NORTH ANNA - UNIT 2

## DISCUSSION OF PROPOSED TECHNICAL SPECIFICATION CHANGES

Figure 6.2-1 Offsite Organization for Facility Management and Technical Support

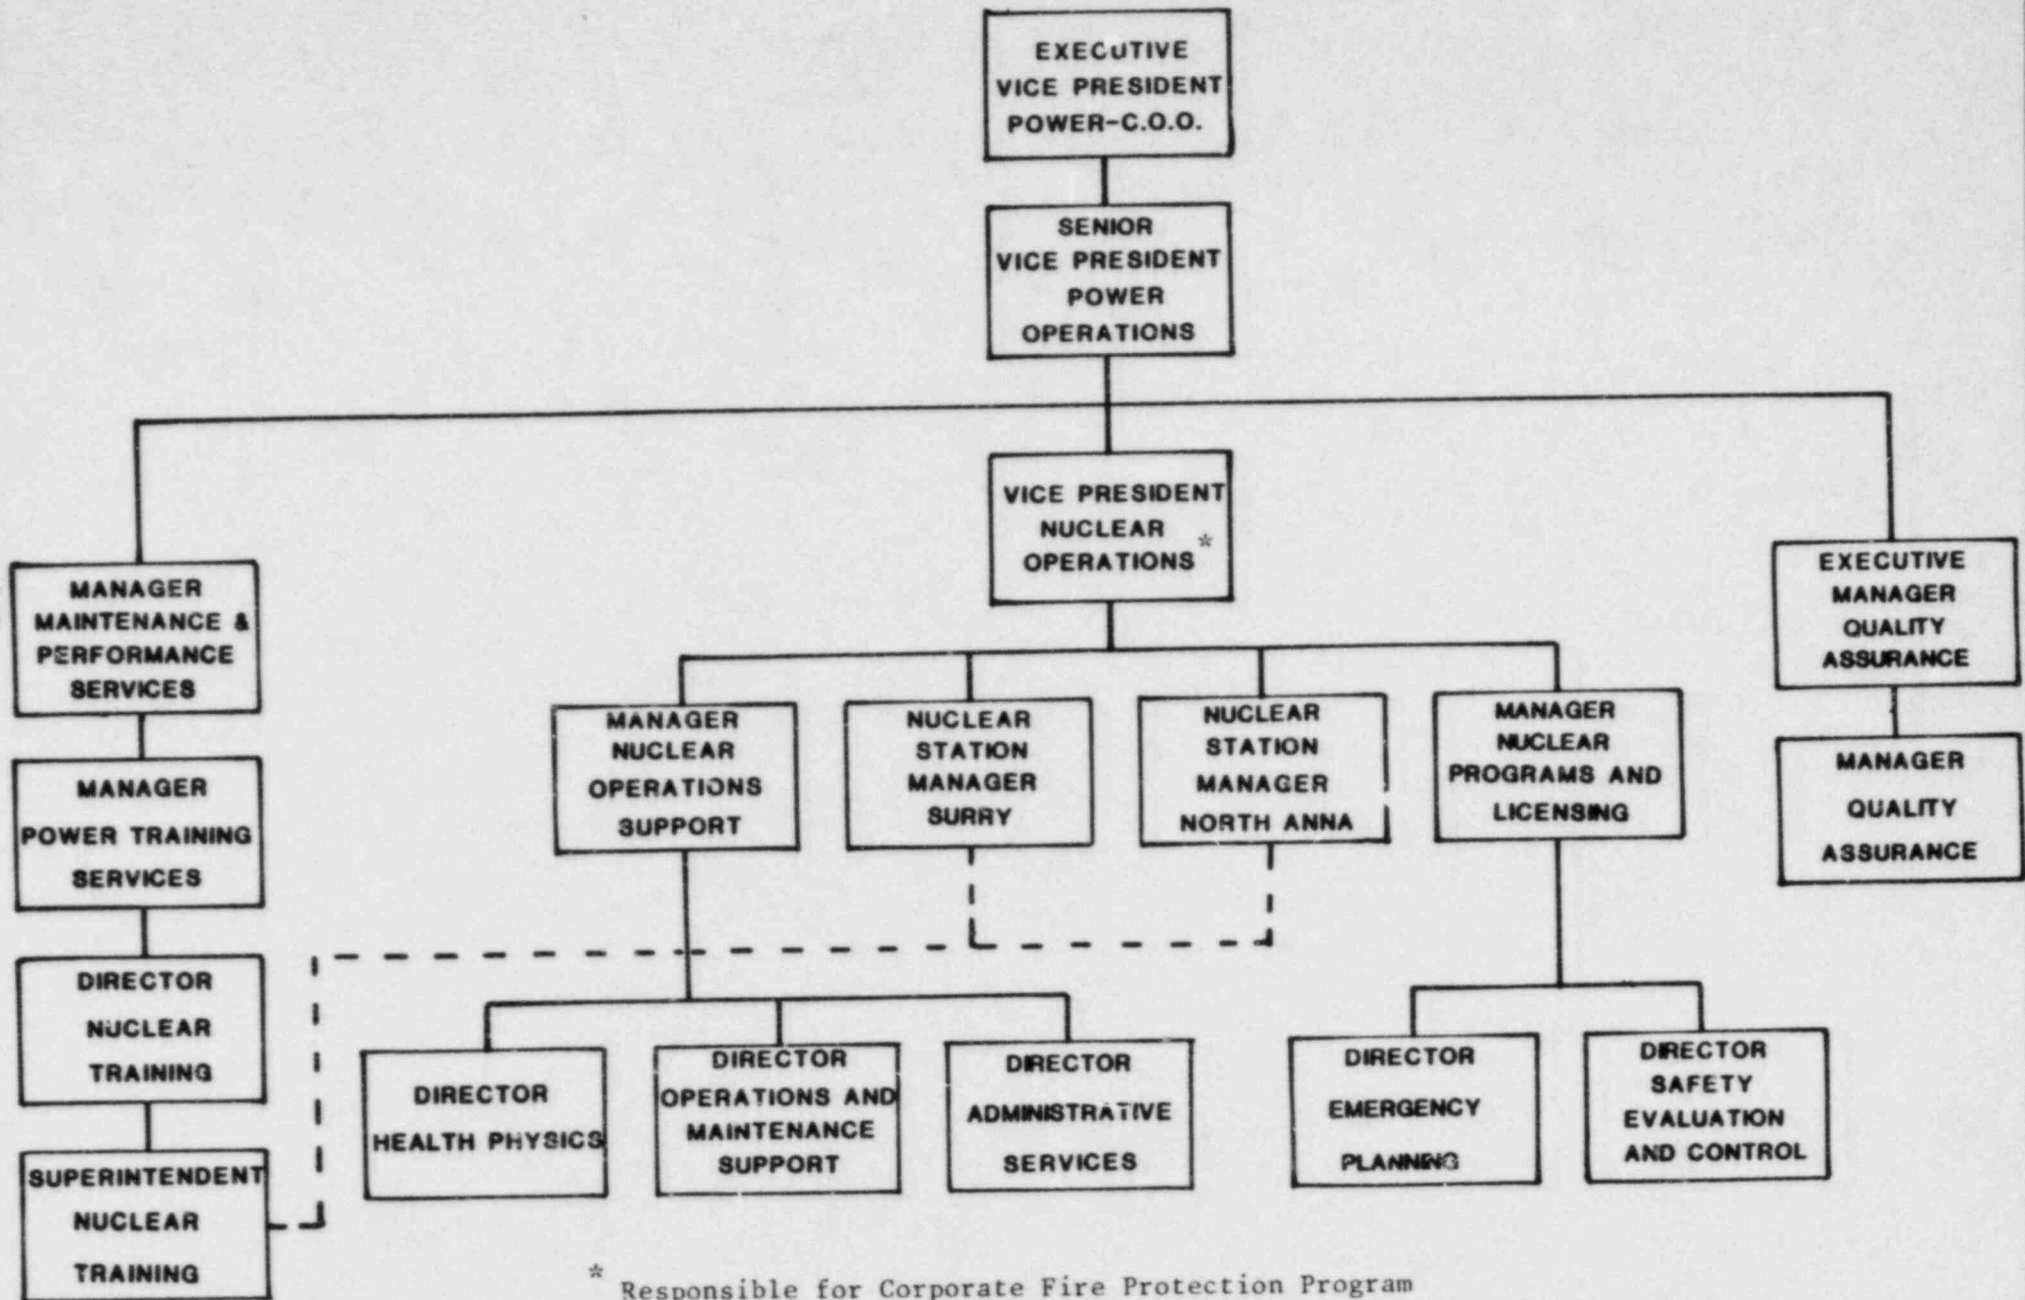
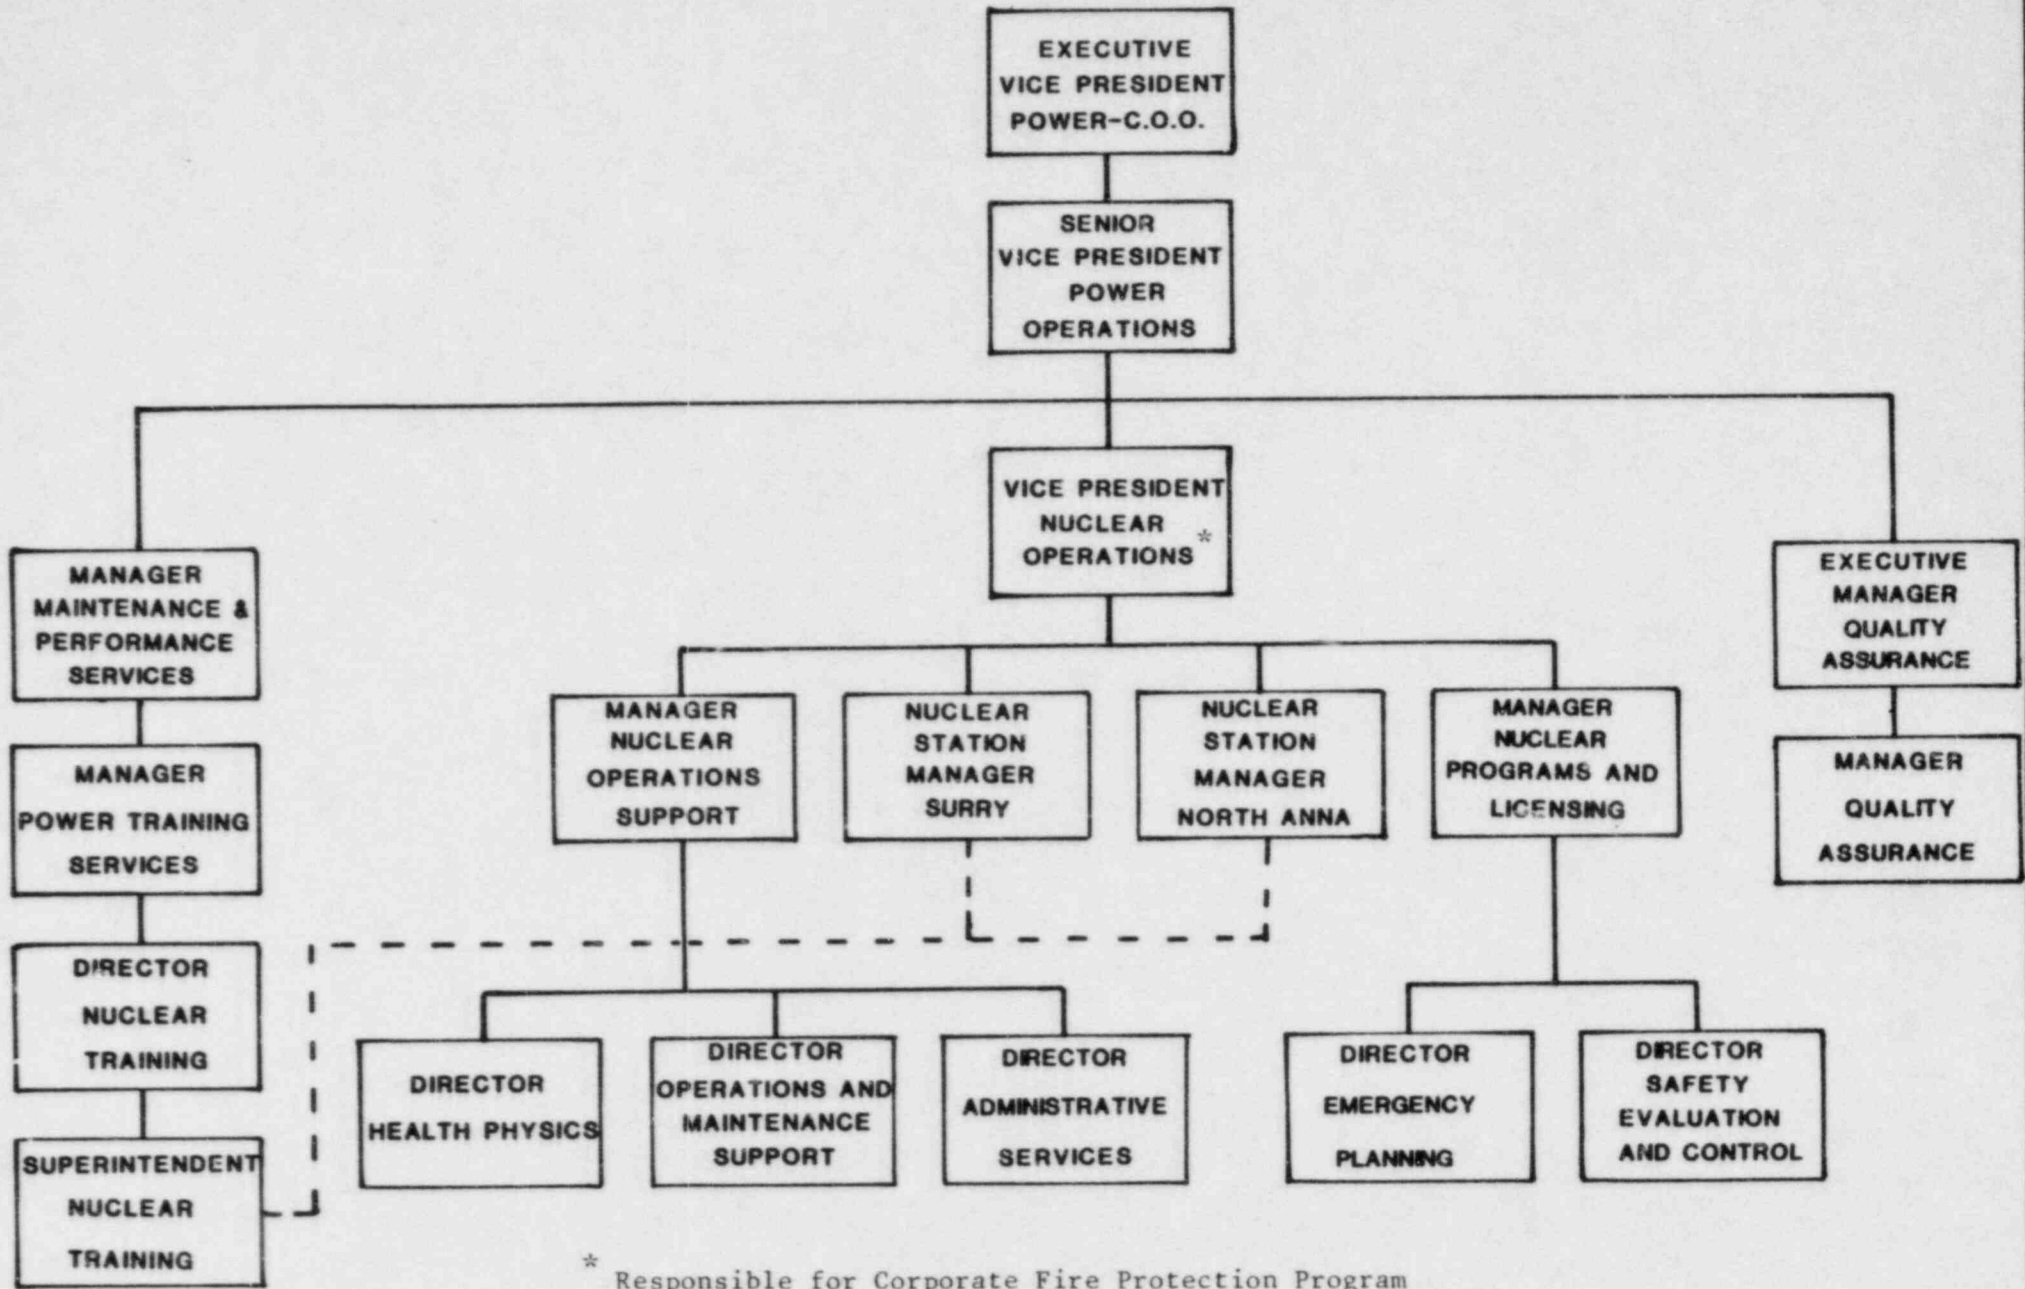
The changes in the Nuclear Operations Department begin with the creation of the Manager, Nuclear Programs and Licensing. The Manager, Nuclear Programs and Licensing reports to the Vice President-Nuclear Operations. His responsibilities and authorities are in the areas of emergency planning, licensing and independent review. Another newly created position is the Assistant Station Manager (Nuclear Safety and Licensing). He reports to the Station Manager and assumes certain responsibilities and authorities previously held by the Station Manager and Assistant Station Manager (Operations and Maintenance) in the area of the Station Nuclear Safety and Operating Committee. He also has responsibility and authority for emergency planning, the safety engineering staff and licensing. The title of the other Assistant Station Manager before the creation of the Assistant Station Manager (Nuclear Safety and Licensing) has been changed to the Assistant Station Manager (Operations and Maintenance). His responsibility and authority have not changed.
